City of Pensacola

Memorandum

File #: 21-18

PROPOSED ORDINANCE 21-18 - AN ORDINANCE CREATING SECTION 12-2-25 OF THE CODE OF THE CITY OF PENSACOLA, PROVIDING FOR THE CRA URBAN DESIGN OVERLAY DISTRICT

Table 12-2-25.3 -Single Family Detached and Two-Family Attached (Duplex) Residential Building Types- R-1AAA through R-1A

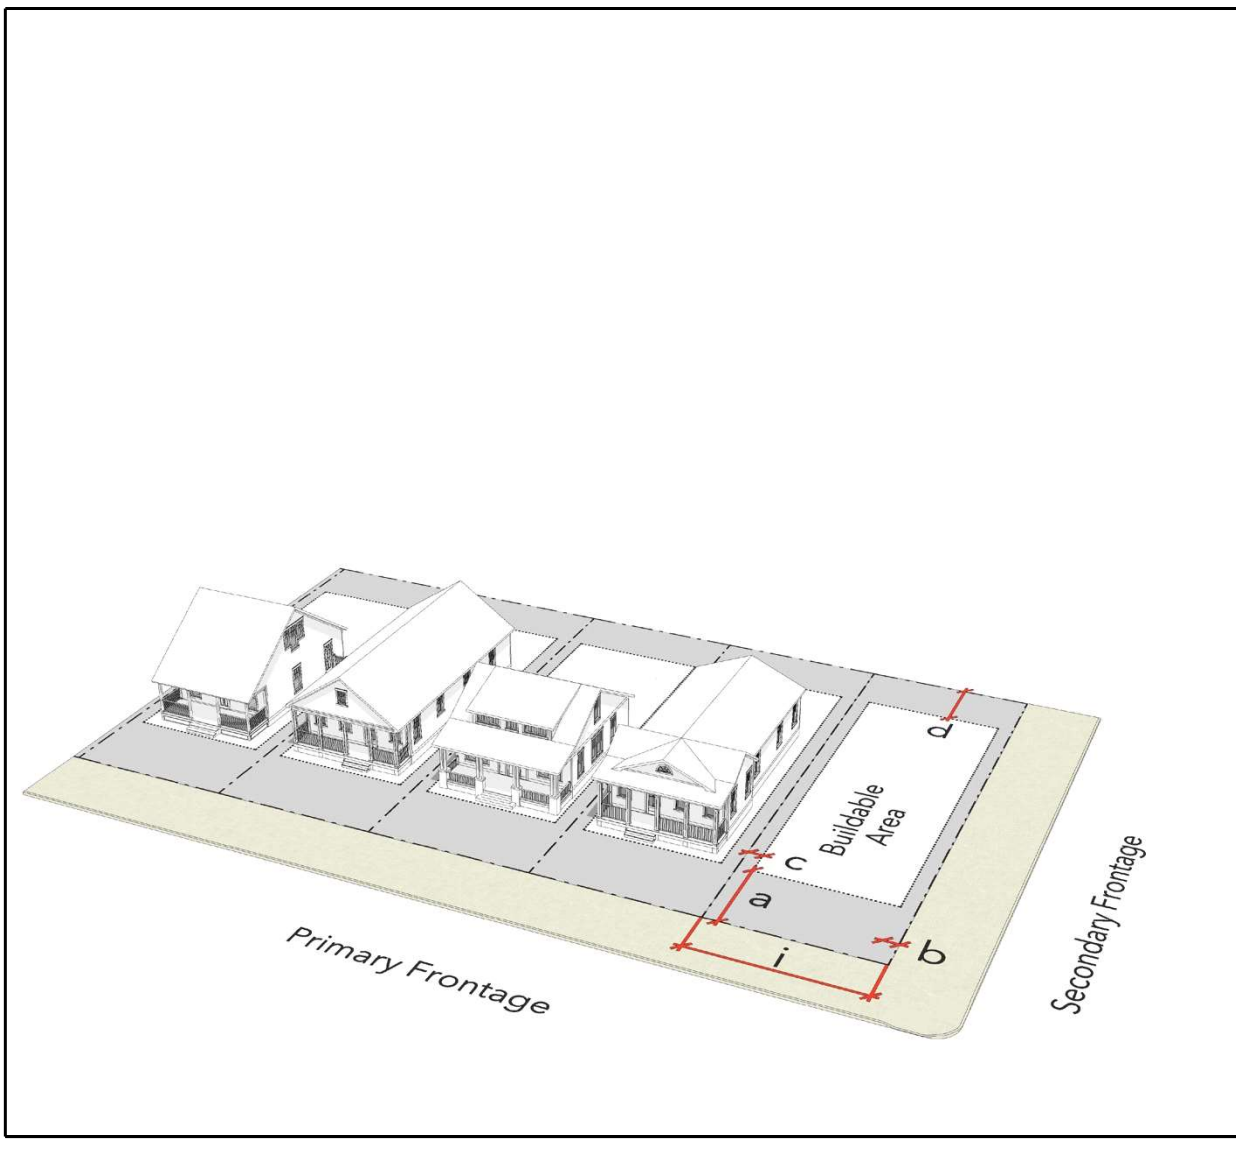
- c. Side and rear setbacks for single family detached and duplex developments on thirty-foot (30') lots should be reduced as follows:
 - a. Side setback reduction from five (5) feet to three (3) feet for single family detached and duplex buildings (Tables 12-2-25.3 and 12-2-25.4).
 - b. Rear setback reduction from 25-30' to 20' for single family detached and duplex buildings (Tables 12-2-25.3 and 12-2-25.4).

- (1) Measured according to Section 12-2-25(G)(a)(c).
- (2) See Section 12-2-25(G)(h)(b) for exceptions.
- (3) Lot width shall only be measured from the right-of-way line. Lot width at the building setback
- (4) [Minimum side yard setback for thirty-foot \(30'\) lots shall be three \(3\) feet measured from the required per applicable Florida Building Code.](#)

Table 12-2-25.4 -Single-Family Detached and Two-Family Attached (Duplex) Residential Building Types- R-1B through C

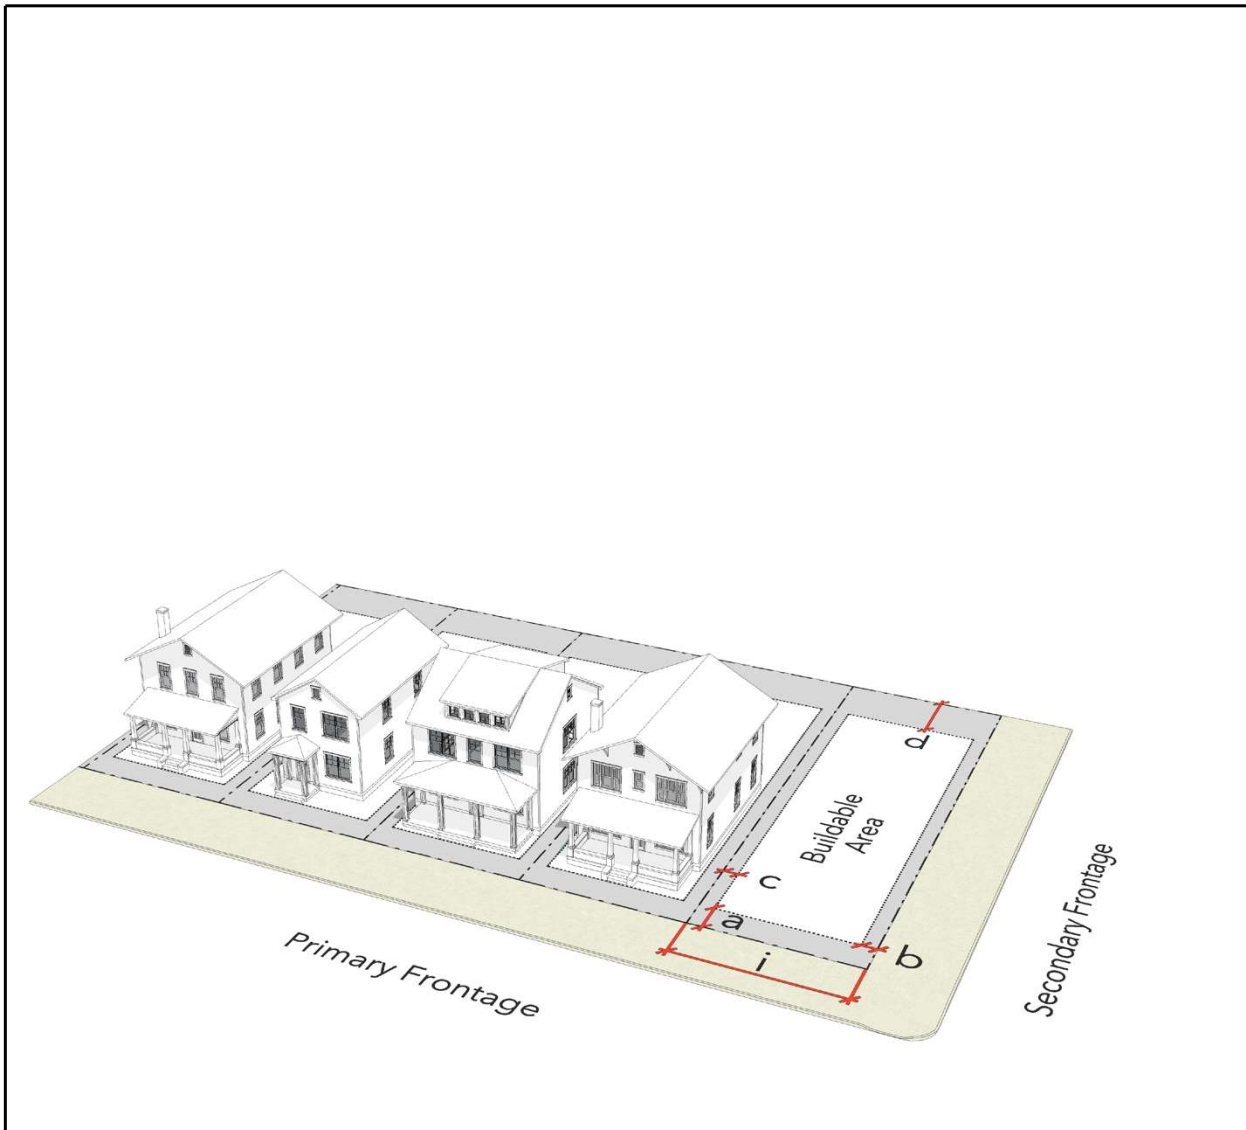
- (1) Measured according to Section 12-2-25(G)(a)(c).
- (2) See Section 12-2-25(G)(h)(b) for exceptions.
- (3) Lot width shall only be measured from the right-of-way line. Lot width at the building setback
- (4) [Minimum side yard setback for thirty-foot \(30'\) lots shall be three \(3\) feet measured from the per applicable Florida Building Code.](#)
